October 8, 2018

Champlain Towers South  
8777 Collins Avenue  
Surfside, FL 33154

**Re: Champlain Towers South Condominium  
Structural Field Survey Report  
MC Job# 18217**

Figure A1: Exterior sealant past its serviceable lifespan at sealant between the window/door frames and masonry/concrete walls & balcony floors

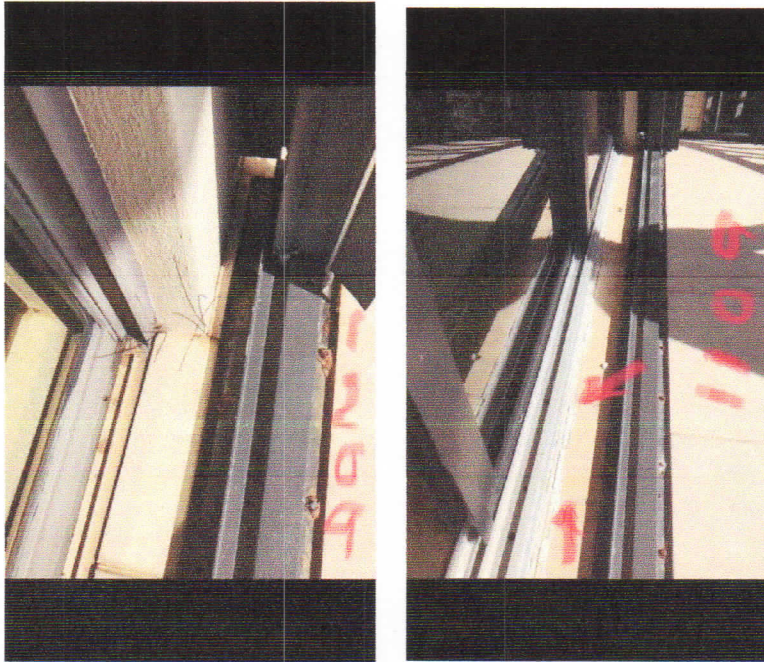
- A. MC understands some unit owners have complained of flooding into the interior space of their unit during a hurricane event. MC has concluded that this infiltration is occurring through the balcony sliding glass doors & windows due to the lack of proper flashing at the sill of these doors & windows and deteriorated exterior perimeter sealant between the window/door frames and masonry/concrete walls. MC recommends that the exterior sealant be removed / replaced at the sliding glass door & window perimeter to assist in providing a water-tight condition. Unfortunately, the new sliding doors in unit 209 and above were not installed properly and were fabricated too tall to allow the base flashing to be properly installed, so these unit owners have no choice but to discard the newly purchased doors and have them completely refabricated.

Figure C: Concrete spall at balcony slab edge in units 1008 & 211

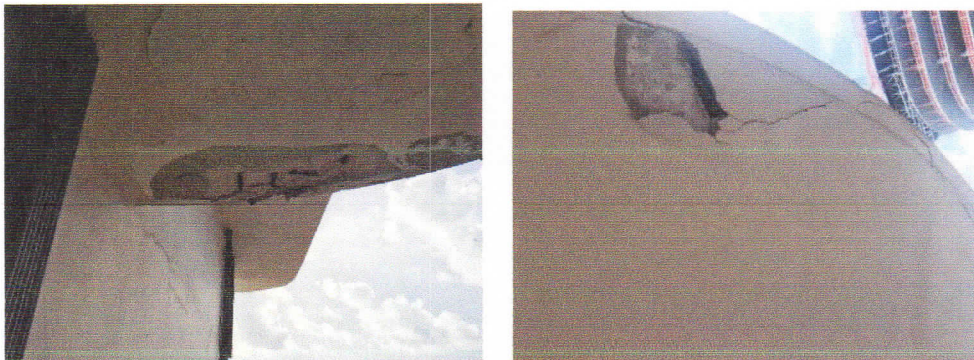
- C. MC found it fairly typical that the concrete slab edges of the balconies are experiencing concrete spalling or cracking. MC sees this as a common source of water infiltration and a main cause of the commonly found, sub-surface deterioration at the exterior soffits under the railings. MC requires that the balcony slab edges be further investigated and repaired in accordance with the recommendations of the ICRI to prevent future water penetration.

Figure E: Deteriorated plywood soffit above entrance drive.

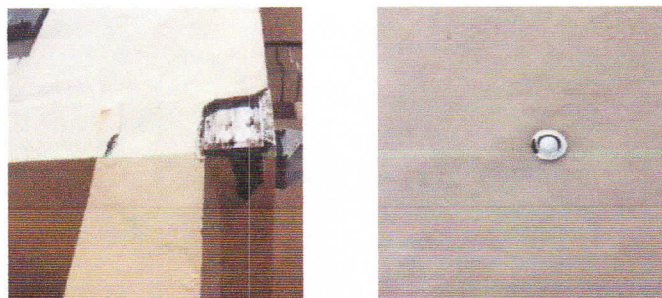
- E. Several areas of the entrance drive soffits under the second floor were observed by MC to have deteriorated black plywood. This condition was also observed at several light fixtures in the entrance soffit. MC could not get access into the soffit areas to observe the extent of the deteriorated soffits and support framing as CTS maintenance was too busy to assist us. MC is concerned that mold exists above these soffit areas and the soffit support framing is deteriorated which will require the complete removal and replacement of the entrance suspended soffit. Further investigation into this area is warranted.

Figure G: Typical cracking in the stucco exterior facade.

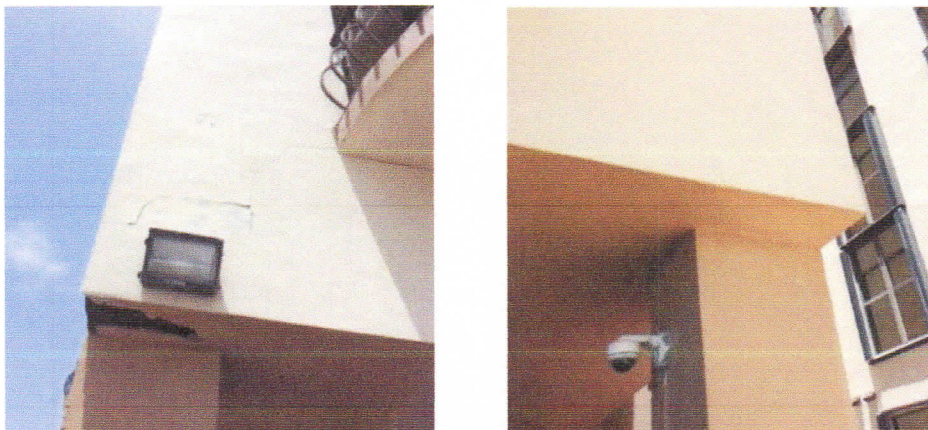
- G. Significant cracking in the stucco exterior façade often occurs at the mortar bed joint between the top of the concrete floor slab and first block masonry course. Although MC does not see this crack as a source of water infiltration into the condominium units, such cracks need to be routed and repointed to prevent future water permeation. All significant façade stucco cracking is to be repaired in accordance with the recommendations of ICRI.

Figure J1: Typical cracking and spalling at parking garage columns

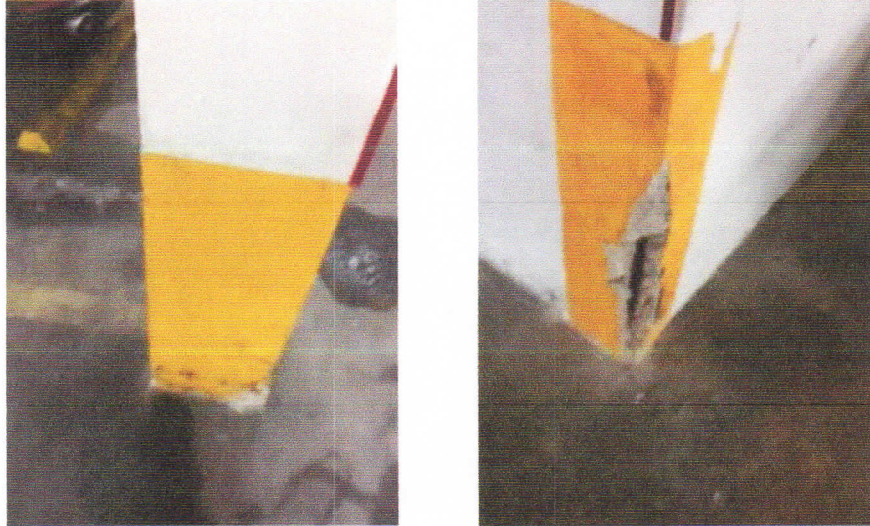
- J. Abundant cracking and spalling of varying degrees was observed in the concrete columns, beams, and walls. Several sizeable spalls were noted in both the topside of the entrance drive ramp and underside of the pool/entrance drive/planter slabs, which included instances with exposed, deteriorating rebar. Though some of this damage is minor, most of the concrete deterioration needs to be repaired in a timely fashion. All cracking and spalling located in the parking garage shall be repaired in accordance with the recommendations of ICRI.

Figure K1: Previously installed failed injection repairs with leaching forming

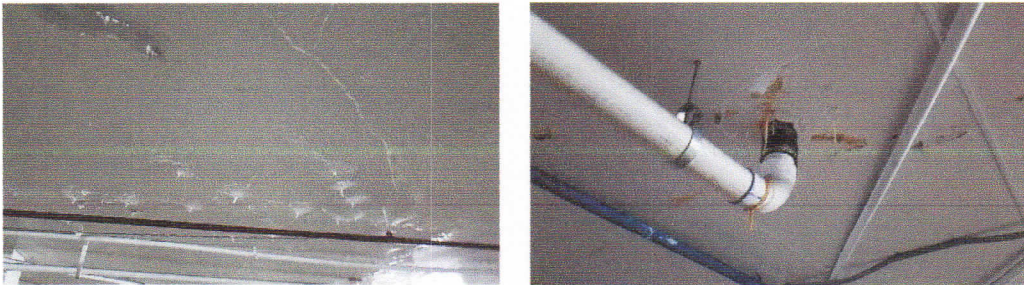
- K. MC visual observations revealed that many of the previous garage concrete repairs are failing resulting in additional concrete cracking, spalling and leaching of calcium carbonate deposits. At the underside of Entrance/Pool deck where the slab had been epoxy-injected, new cracks were radiating from the originally repaired cracks. The installed epoxy is not continuous as observed from the bottom of the slab, which is evidence of poor workmanship performed by the previous contractor. The injection ports were not removed, and the surfaces were not ground smooth at the completion of the injection. Leaching of calcium carbonate deposits in numerous areas has surely caused CTS to pay to repaint numerous cars. This leaching will continue to increase until proper repairs are completed. MC is convinced that the previously installed epoxy injection repairs were ineffective in properly repairing the existing cracked and spalled concrete

slabs. MC recommends that the Entrance/Pool deck concrete slabs that are showing distress be removed and replaced in their entirety. Unfortunately, all of these failed slab areas are under brick pavers, decorative stamped concrete and planters which require completed waterproofing replacement. All repaired concrete slabs located in the parking garage are to be repaired in accordance with the recommendations of ICRI.
